FINAL ENVIRONMENTAL IMPACT REPORT

SHERMAN OAKS - STUDIO CITY - TOLUCA LAKE - CAHUENGA PASS COMMUNITY PLAN AREA

*Harvard-Westlake School
Parking, Safety and Athletic Improvement Plan
Case Number: ENV 2013-0150-EIR
State Clearinghouse No. 2013041033*

Figure 3.7-2

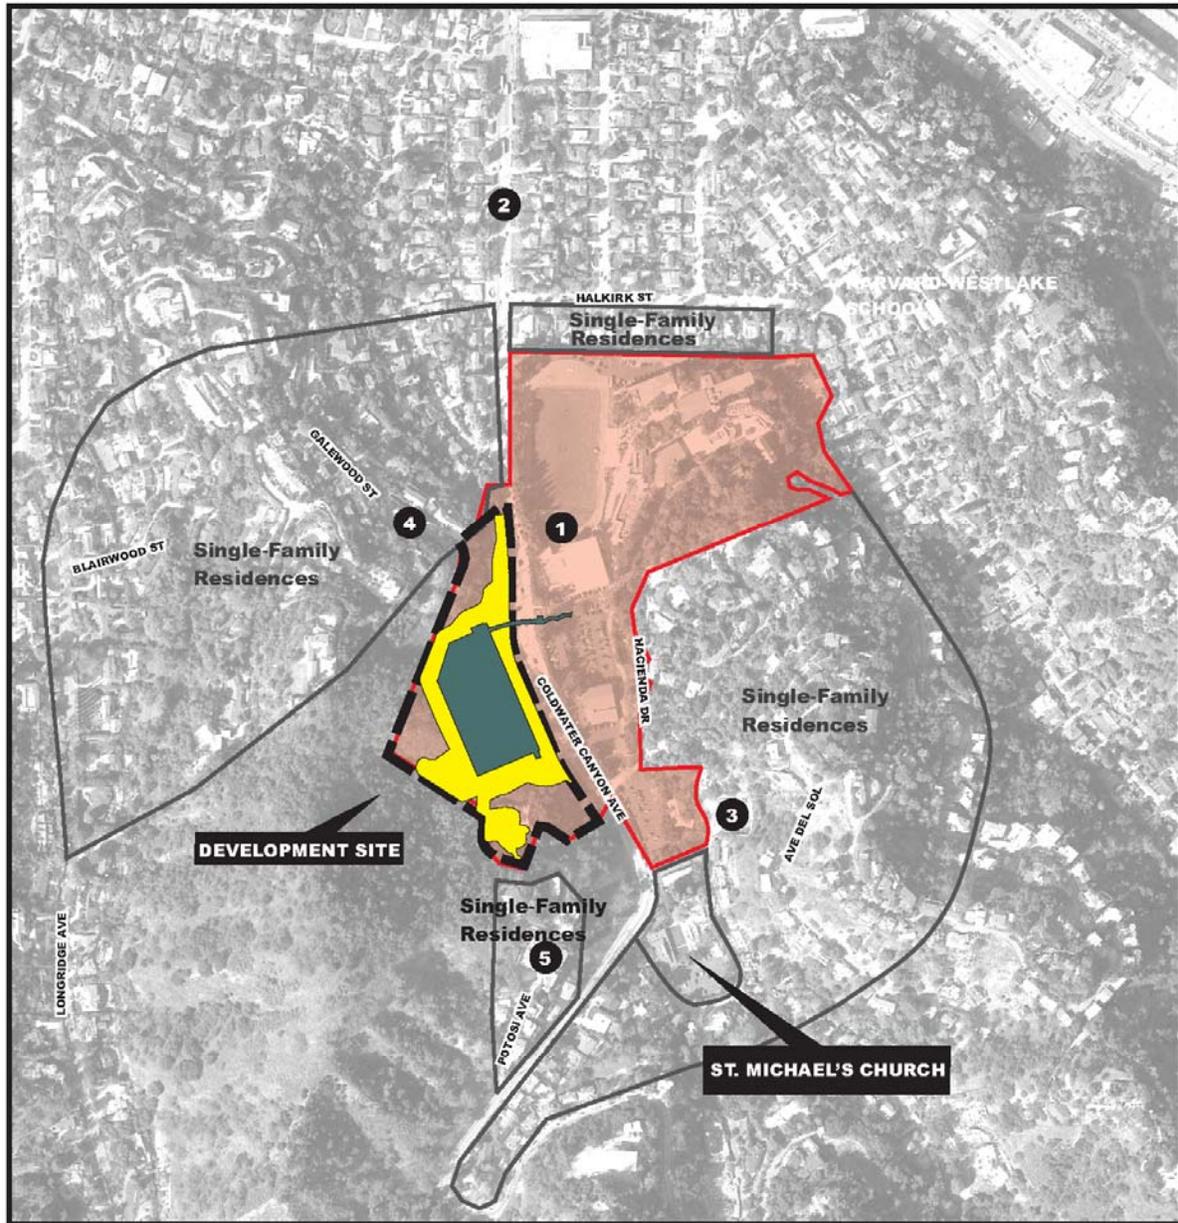
Pages 3.7-5, 3.7-3, and 3.7-4; Figures 3.7-2, 3.7-3 and 3.7-4 are revised to show the revised construction limits to include the removal of the house on Potosi Avenue.

Figure 3.8-1
Existing Parking and Drop Off Zones

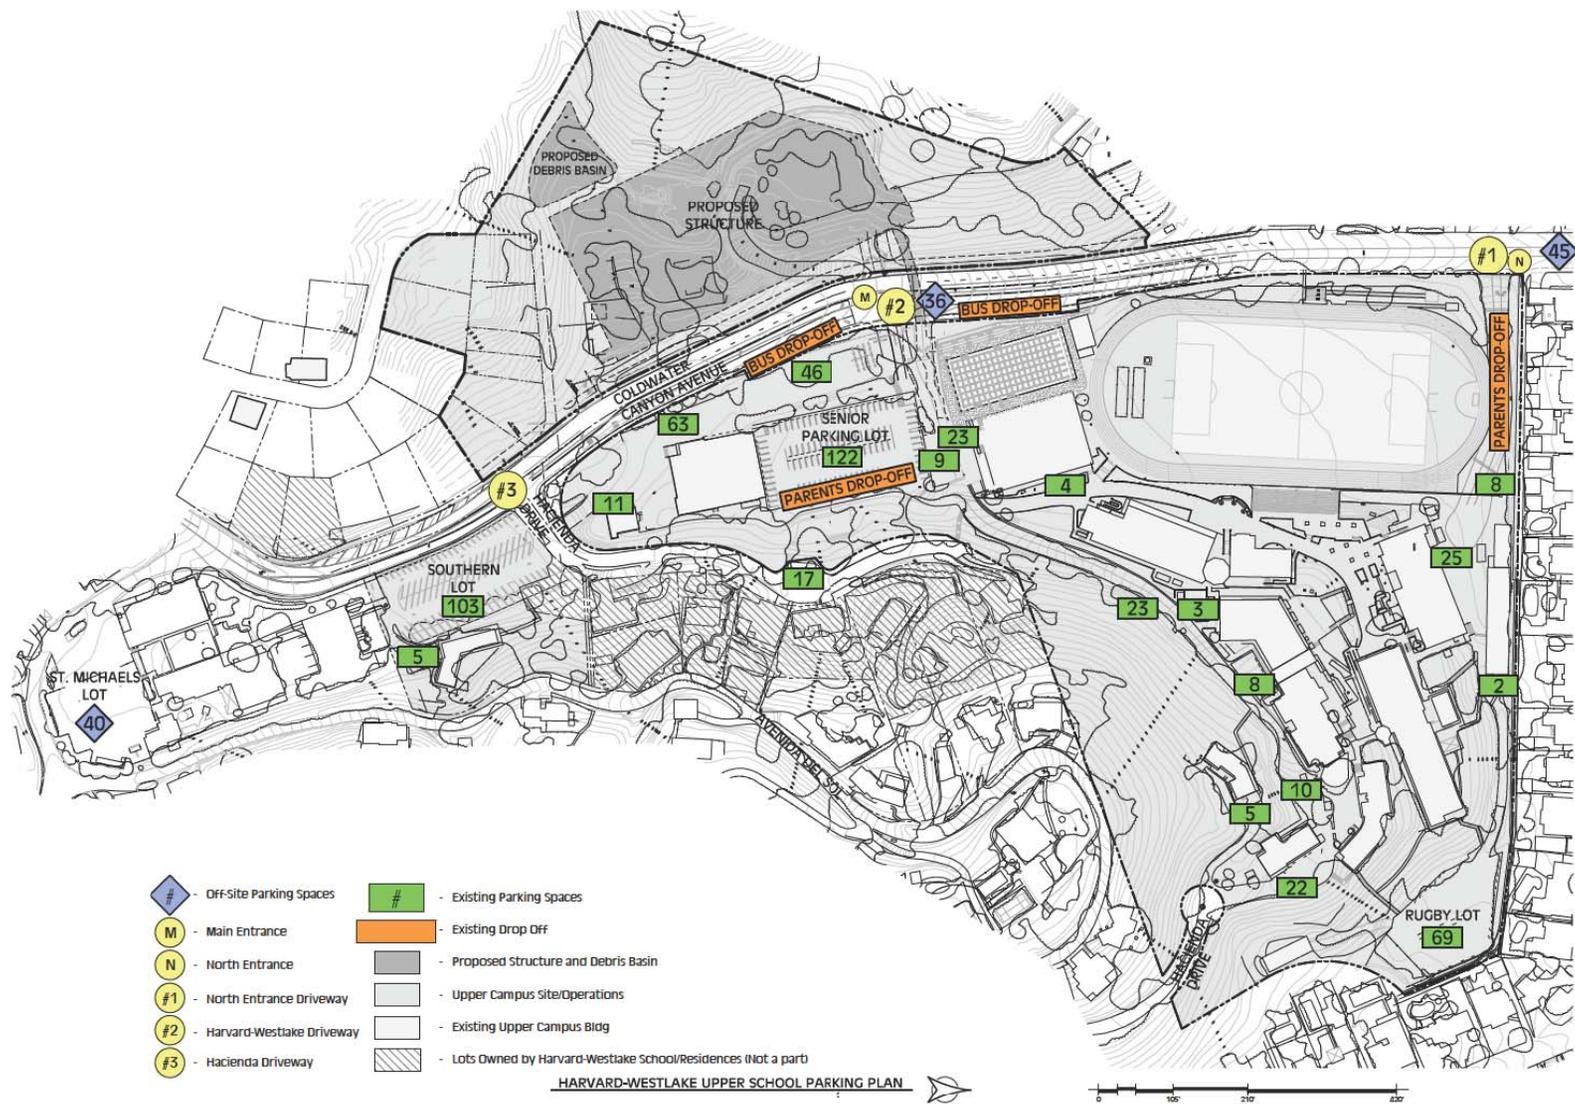
Page 3.8-7, Figure 3.8-1, is revised to show removal of the house on Potosi Avenue; see following.
